PARTS & SERVICES		Technical Service Bulletin (TSB) Global Telematics Box (TBM) Firmware Over The Air (FOTA) Update To SW 4.39			
REFERENCE:	TSB: 08-296-26 GROUP: 08 - Electrical	Date:	July 28, 2026	REVISION:	—
VEHICLES AFFECTED:	2025 (WD) Dodge Durango This bulletin applies to vehicles equipped with Global Telematics Box Module (Sales Code RDG).			MARKET APPLICABILITY: ☒ NA ☐ MEA ☐ SA ☐ IAP ☐ EE ☐ CH NOTE: This bulletin applies to the North America market.	
CUSTOMER SYMPTOM:	Customers must experience a Malfunction Indicator Lamp (MIL) illumination and one or more of the following Diagnostic Trouble Codes (DTCs): • B22A9-96 - ECU Internal Performance-Component Internal Failure. • B1560-11 - Cellular Antenna 1-Circuit Short To Ground. • B1560-13 - Cellular Antenna 1-Circuit Open. • B1561-11 - Cellular Antenna 2-Circuit Short To Ground. • B1561-13 - Cellular Antenna 2-Circuit Open. • B1562-14 - GPS Antenna-Circuit Short To Ground Or Open. Customers may also experience the following: • "UConnect Box Requires Service" Message in Radio Display.

Fig. 1

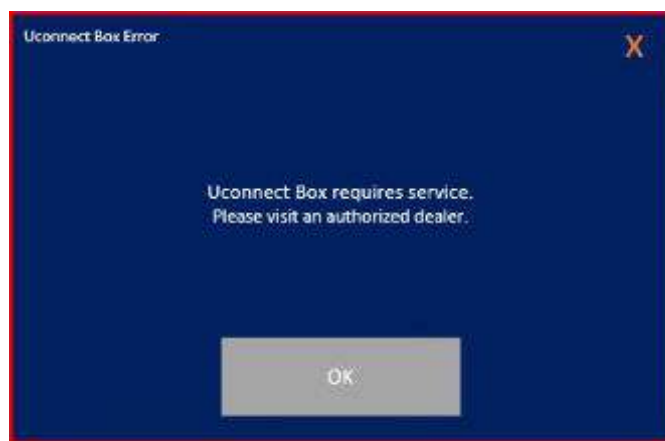
Message display on the radio screen "Uconnect Box requires service. Please visit an authorized dealer." [Fig. 1.](#)

This bulletin provides information regarding the latest Firmware Over The Air (FOTA) update and provides the service technician an overview of the steps a customer will need to take to complete the update. The TBM software will be updated from 4.37 and 4.38 to 4.39 (243187 SW PN number).

Fig. 3

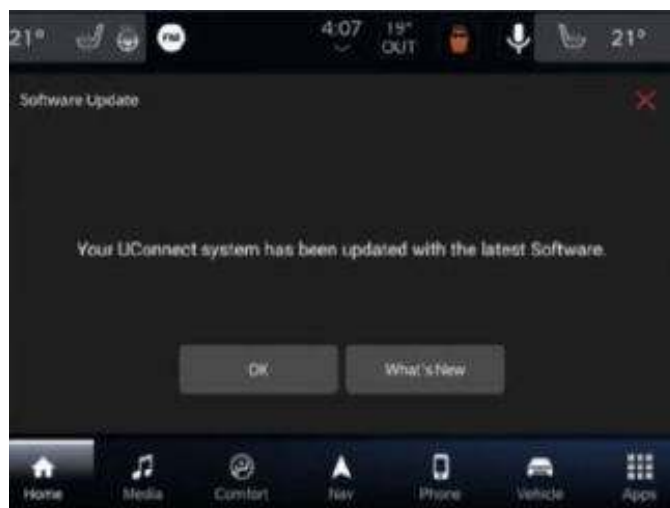
3. Upon completion of update, the radio will display a confirmation message [Fig. 3](#).
